**TOWN OF BAY HARBOR ISLANDS  
MORRIS N. BROAD COMMUNITY CENTER  
1175 95TH STREET  
BAY HARBOR ISLANDS, FL 33154**

**DEVELOPMENT & REVIEW COMMITTEE MEETING**

**TOWN OF BAY HARBOR ISLANDS  
COMMUNITY DEVELOPMENT  
MEMORANDUM**

**Subject:** Site Development Plan Application (4<sup>th</sup> DRC Review)  
1085 Townhouses – 6 DU Townhouse Complex  
1085 94<sup>th</sup> Street  
Bay Harbor Islands Acct. No. SPR24-000025  
MMPA Account No. 01-0702-1197

sheet number  
SCALE: AS SHOWN  
**A-1**

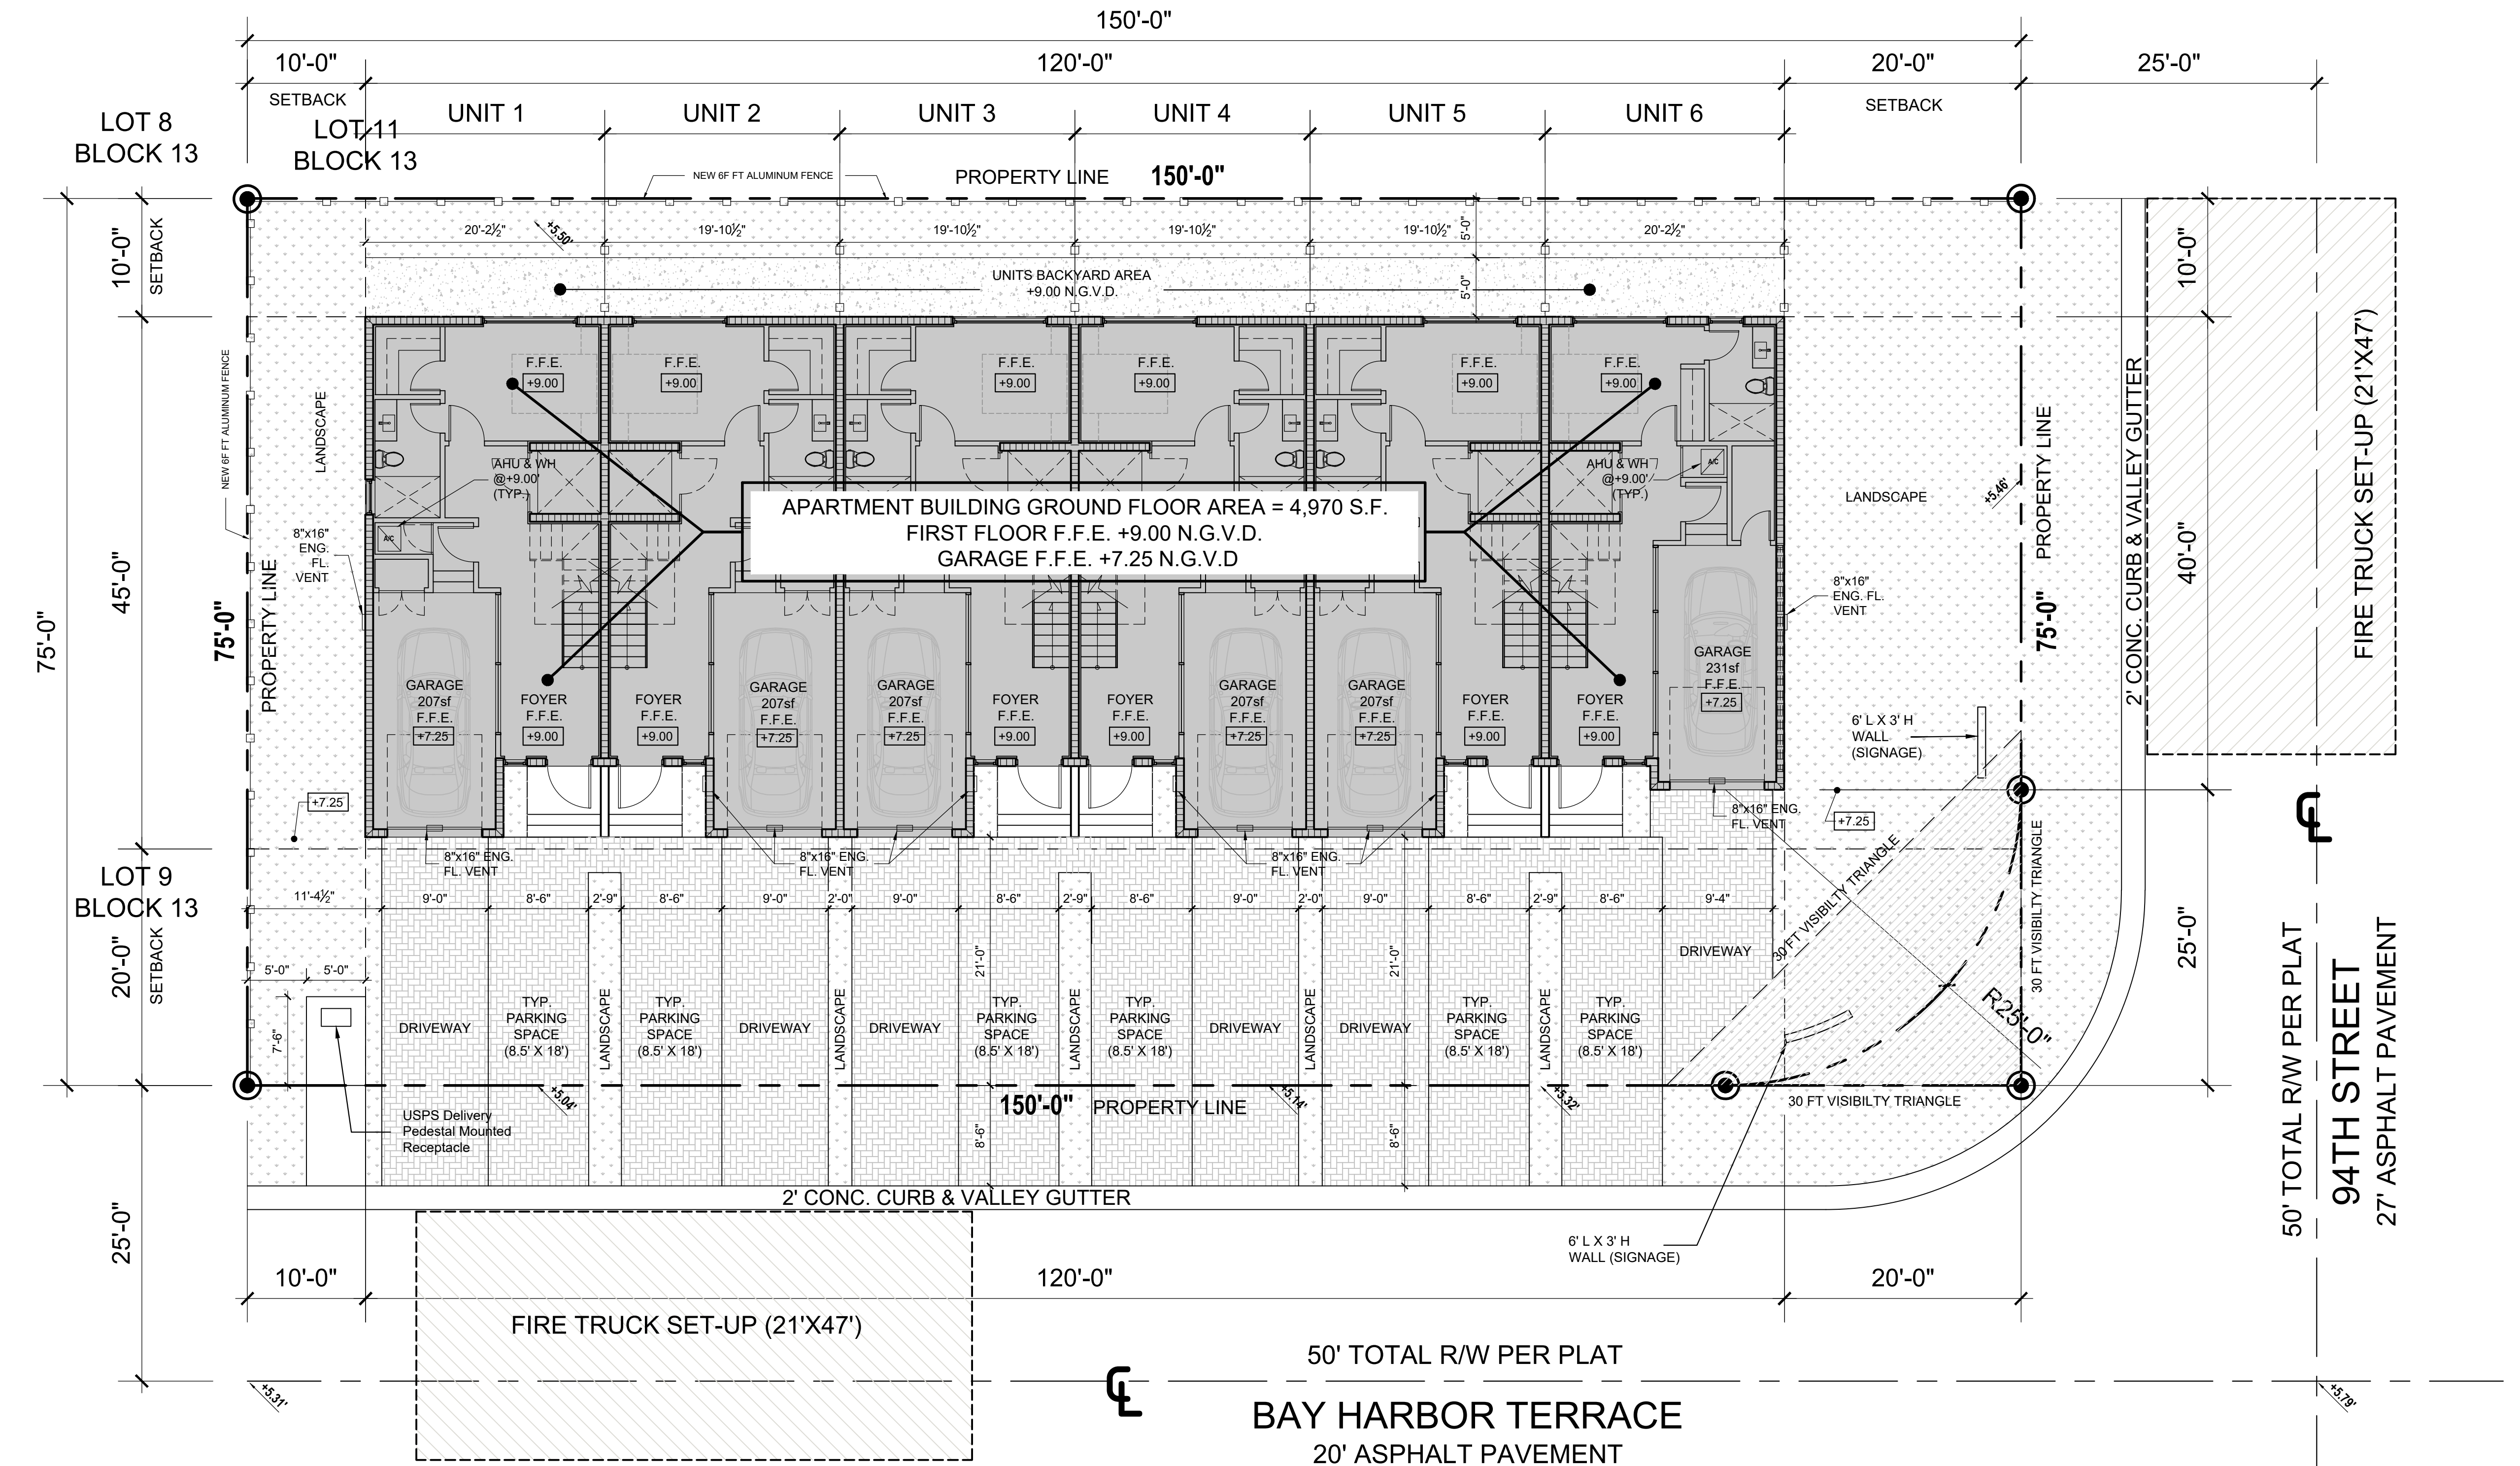
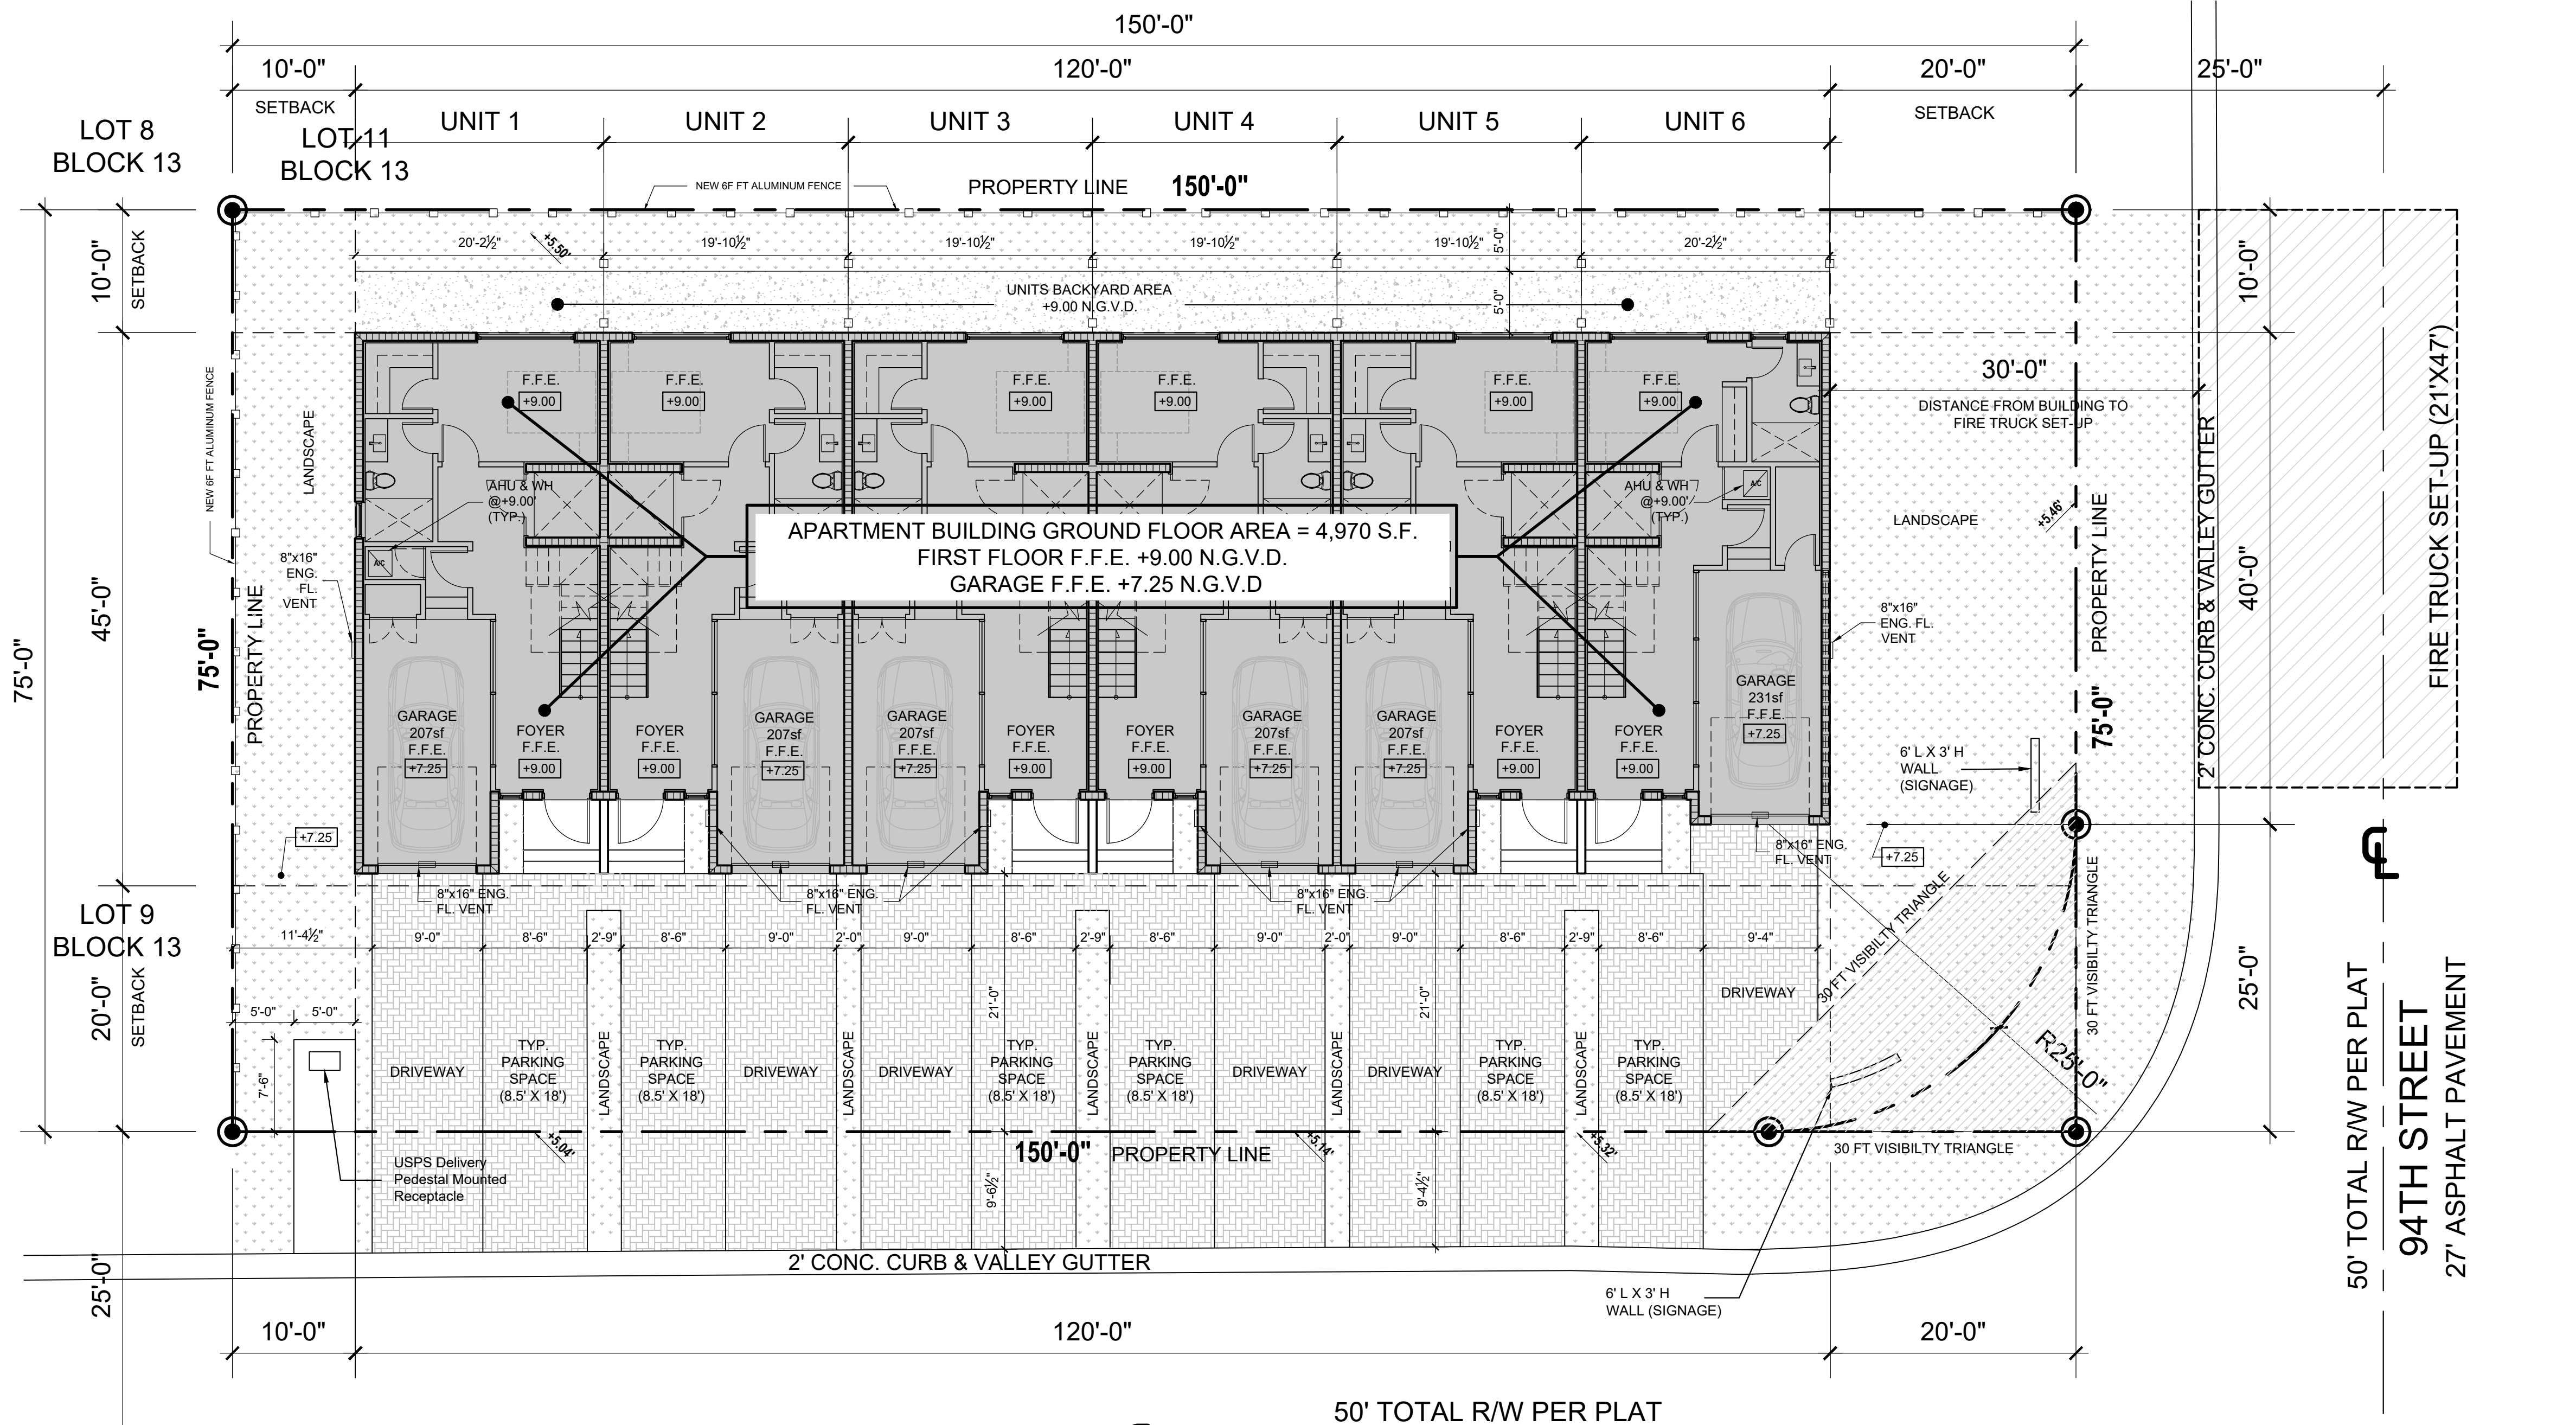
- 3) Site Plan A-1 still has the following issues:
  - a. Again, per Sec. 23-24(d)(6)(b) not more than 50% of a property's street frontage in a townhouse development may have hard drive ay surfaces. MMPA mentioned this at the #2 DRC meeting and requested the p,ans be revised to meet this Code requirement and to provide calculations demonstrating compliance. No calculations have been provided, and it appea the applicant is proposing to use so-called "pervious pavers" to achieve this requirement, but the Code prohibits that. MMPA roughly calculates that about 68.5% of the yard area facing BHT is impervious / not landscaped open space. This is not just about drainage - it is about appearance-the Town wants its streetscapes to have an open/ landscaped look - not hardscapes. The project fails to meet the Code criteria. Revise. Perhaps reorient the unit along 94<sup>th</sup> Street to have its garage facing that roadway.

- d. The Zoning Code requires that a minimum of 20% of the site be landscaped open space. The plans indicate that a minimum of 2,804 sq. ft. is required but 3,100 sq. ft. is to be provided. Please verify that the landscaped open space to be provided does not include the driveways or any other impervious area (USPS concrete pad / walks/ etc.). Revise the plans as necessary to meet Code.

Property's street frontage less than 50% provided as requested. Corner unit driveway modified and facing 94<sup>th</sup> ST as suggested. Please refer to sheet A-1 for calculations and Site Plan for drawings.

Driveways or any impervious area are not part of the 20% calculation.  
Please refer to breakdown area calculations on Sheet A-1
